**BEFORE THE PUBLIC UTILITIES COMMISSION
OF THE STATE OF CALIFORNIA**

Rulemaking 16-02-007
(Filed February 11, 2016)

**COMMENTS OF THE CALIFORNIA WIND ENERGY ASSOCIATION
ON DRAFT INTEGRATED RESOURCE PLANS
OF THE LOAD-SERVING ENTITIES**

Figure 1. The current overall portfolio is very diverse, but many non-solar resources are without long-term contracts.

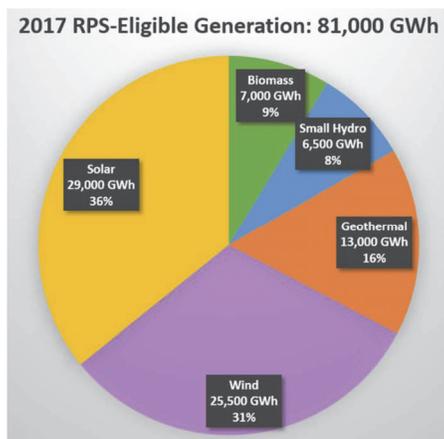
Second, the RSP was based incorrectly on the assumption that existing, mostly pre-RPS, renewable resources operating outside of long-term contracts will continue to operate until 2030.¹⁵ But most existing, pre-RPS resources will need to be re-contracted or replaced in order to maintain the assumed baseline level of renewable resources. In the case of wind energy, over 1,000 MW of these projects would be 40 years old in 2030, and, given the cost to keep these projects operating, the assumption that these resources will continue to operate based on short-term CAISO market prices is highly questionable. The assumption is even more dubious when applied to a much larger quantity of existing biomass and geothermal resources, whose operating costs are substantially higher than those of existing wind resources.¹⁶ The overly optimistic assumption that the current, very diverse baseline of renewable resources (see Figure 1) will

persist regardless of going-forward purchases led to a solar-dominated plan that almost certainly skewed downward the estimated need for non-solar resources in going-forward procurement.¹⁷

In modeling the Preferred System Plan, therefore, the Commission should place in the supply curve all existing renewable resources that do not have contracts running through 2030 (with existing wind taking the form of potentially repowered projects). This exercise is likely to show that (a) the retention of existing/repowered wind resources would be cost-effective (particularly if procured in the near-term while tax credits are still available), and (b) some existing non-solar renewable resources are likely to decline, leading to a need for additional wind resources and/or more storage. Conducting this analysis this year is important to enable and encourage LSEs to capture the full value of wind energy tax credits with contracts signed in 2019,²⁰ and solar/storage tax credits in the near term.
